CITY OF ALBUQUERQUE

Re: Performance Plus

6900 Huseman Pl SW Grading and Drainage

Re: Performance Plus Additions,

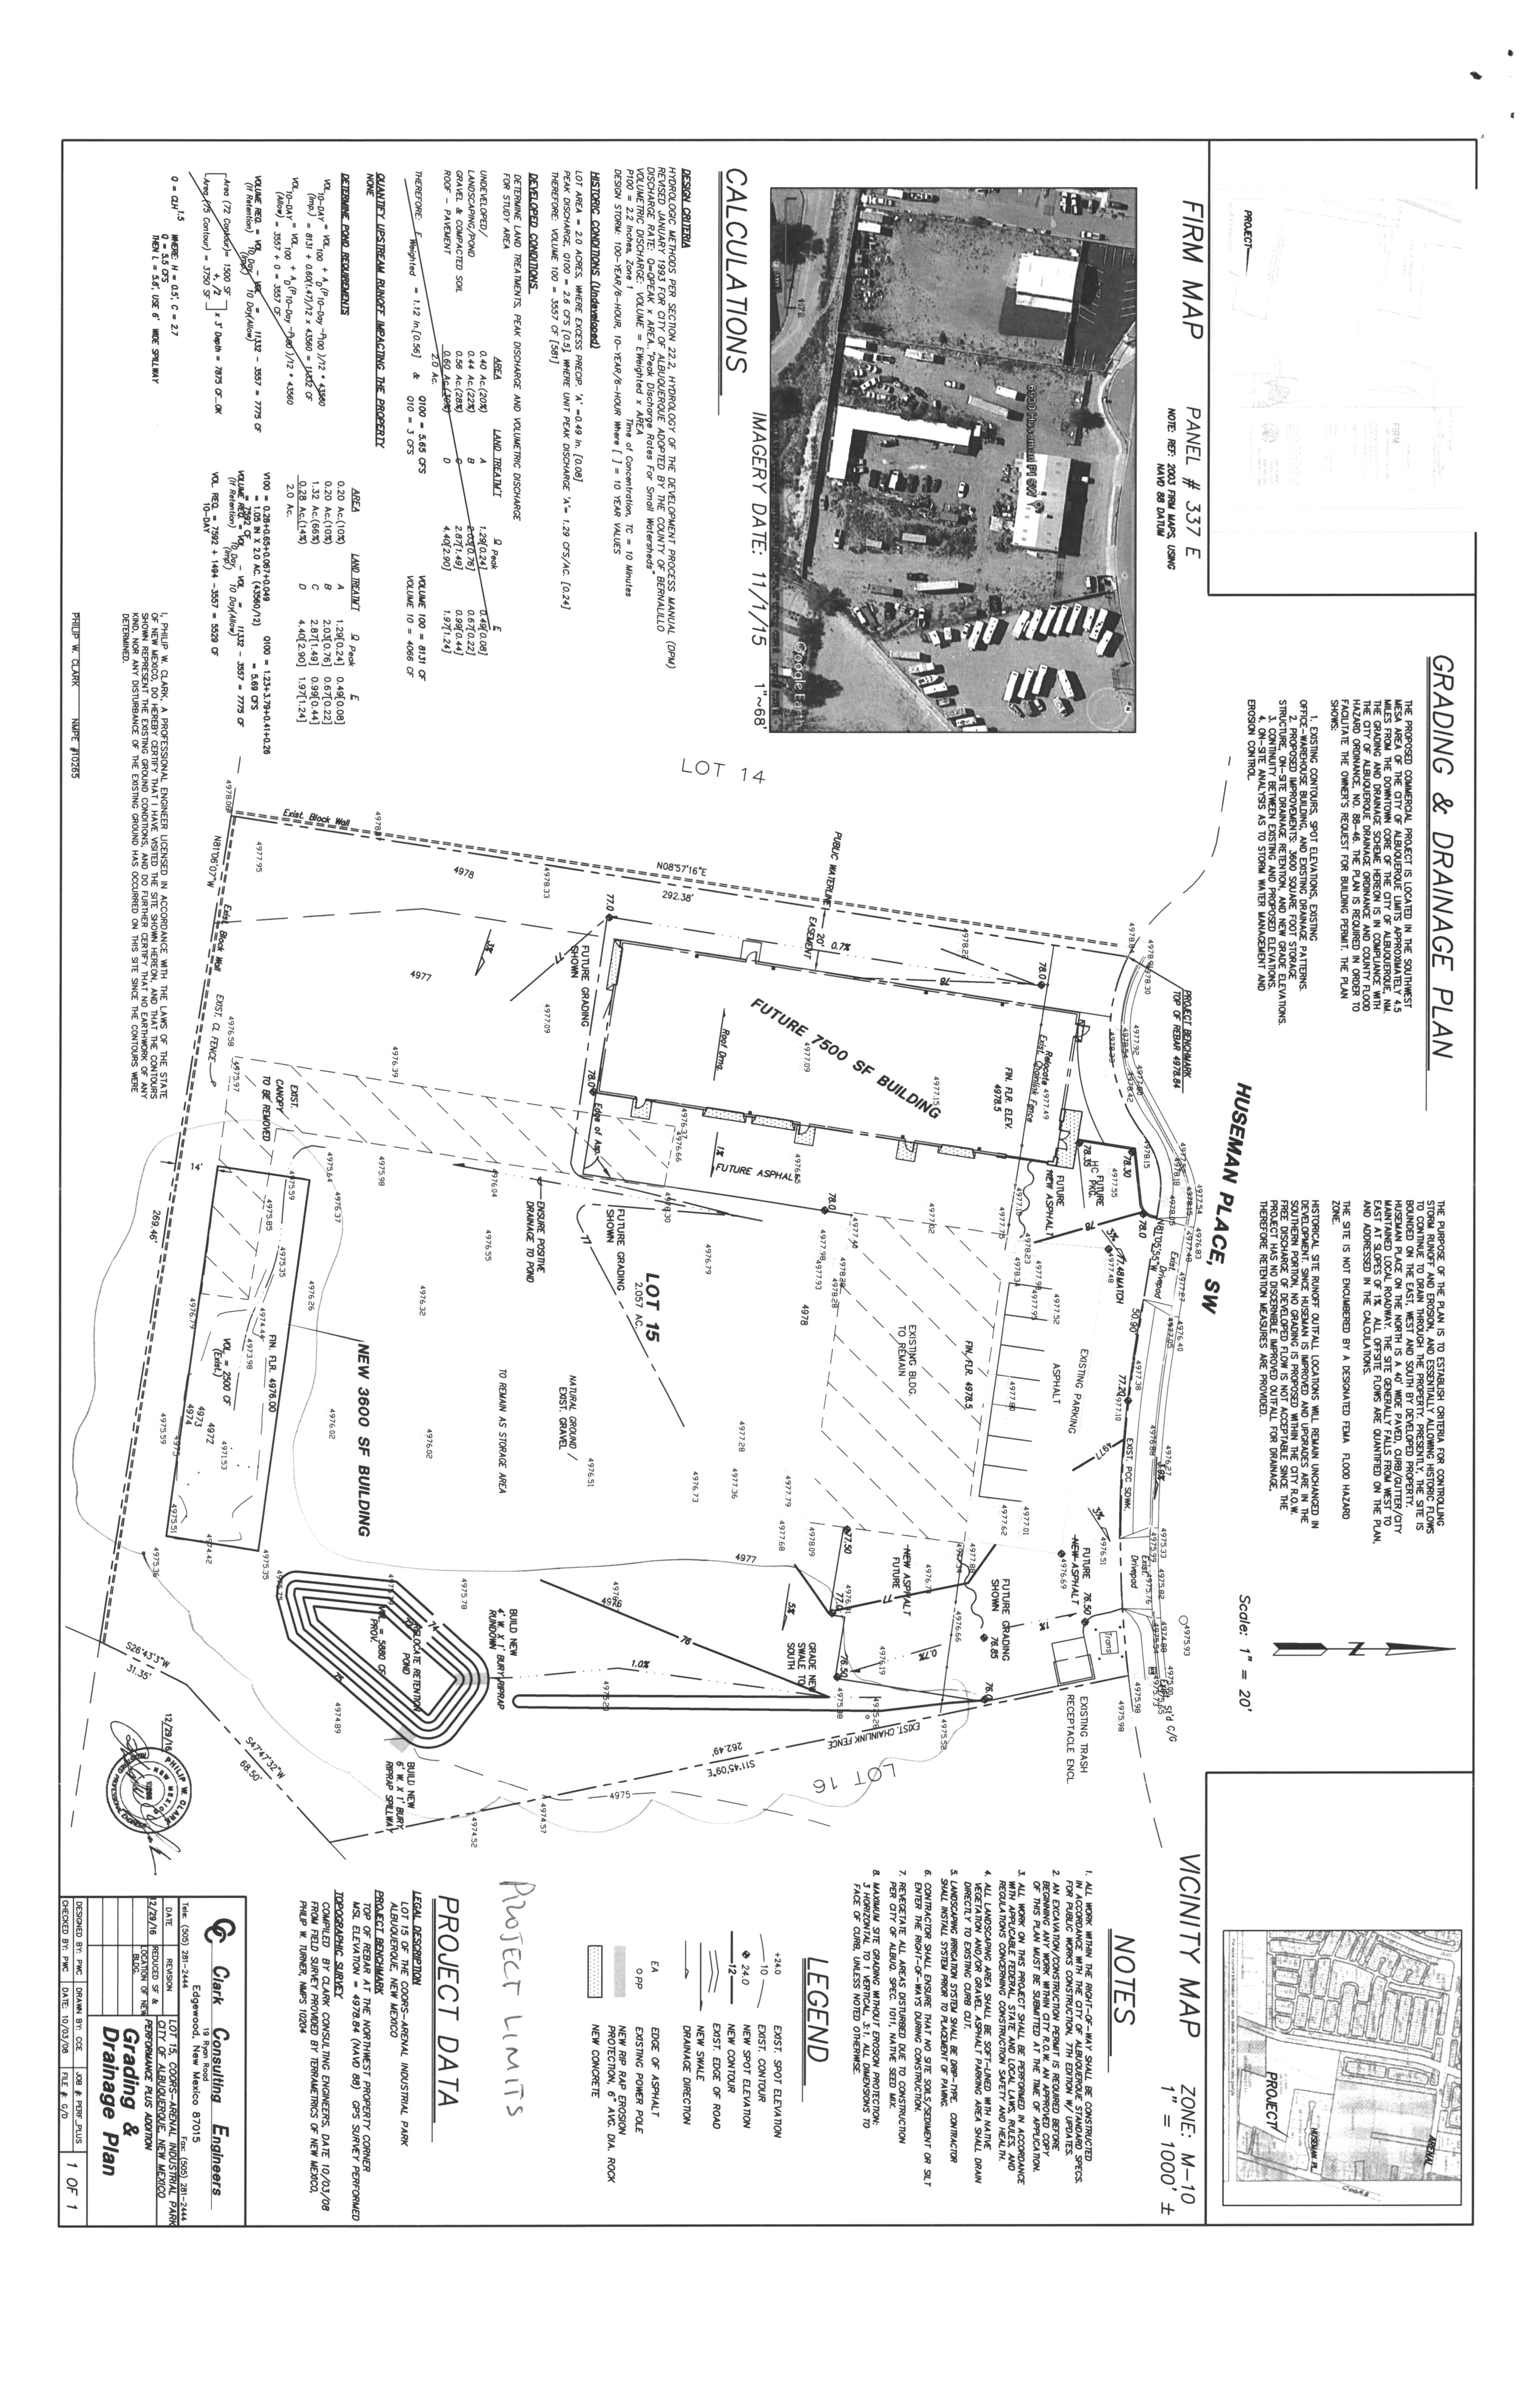
1. Provide the water surface elevation for the proposed expanded retention pond.

2. Please remove the riprap (6'x1') spillway.

3. Extend the earth mound, elevation contour 4976, around the back of proposed retention pond to the northeast corner of existing chain link fence (proximity).
